ATTACHMENT B
License
and
Technical Specification Changes

Lic. Page 3

T.S. Pages 6
7
8
9
18
20
27
54
127
127A
127A-1
205A
205C

Figure 2.1.1

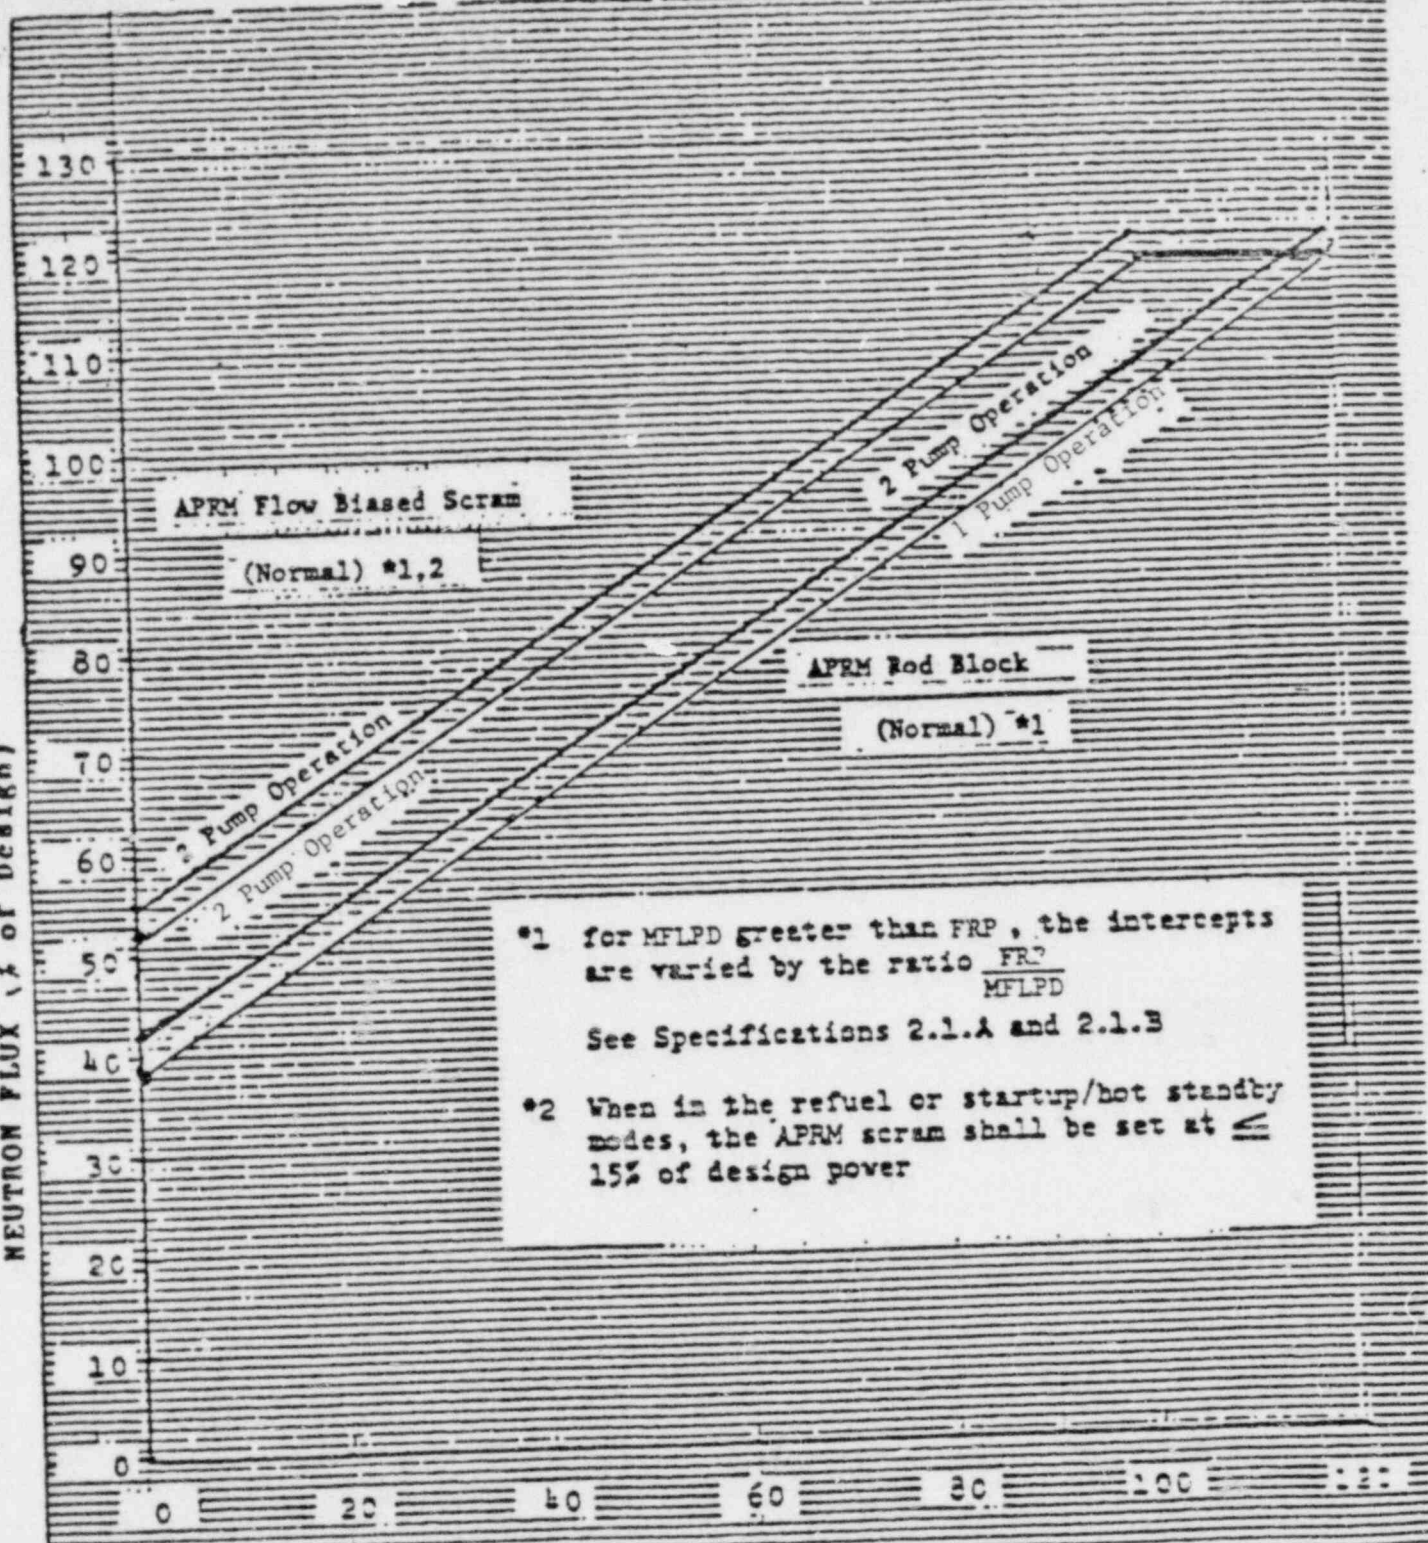
- *1 for MFLPD greater than FRP, the intercepts are varied by the ratio $\frac{FRP}{MFLPD}$
See Specifications 2.1.A and 2.1.B
- *2 When in the refuel or startup/hot standby modes, the APRM scram shall be set at \leq 15% of design power

$$S_{RB} \leq 0.65W + 42\% \quad \underline{2 \text{ Loop}}$$

$$S_{RB} \leq 0.65W + 38.7\% \quad \underline{1 \text{ Loop}}$$

$$S_{RB} \leq (0.65 W + 42\%) \left[\frac{FRP}{MFLPD} \right] \frac{2 \text{ Loop}}{1 \text{ Loop}}$$

$$S_{RB} \leq (0.65 W + 38.7\%) \left[\frac{FRP}{MFLPD} \right] \frac{1 \text{ Loop}}{1 \text{ Loop}}$$
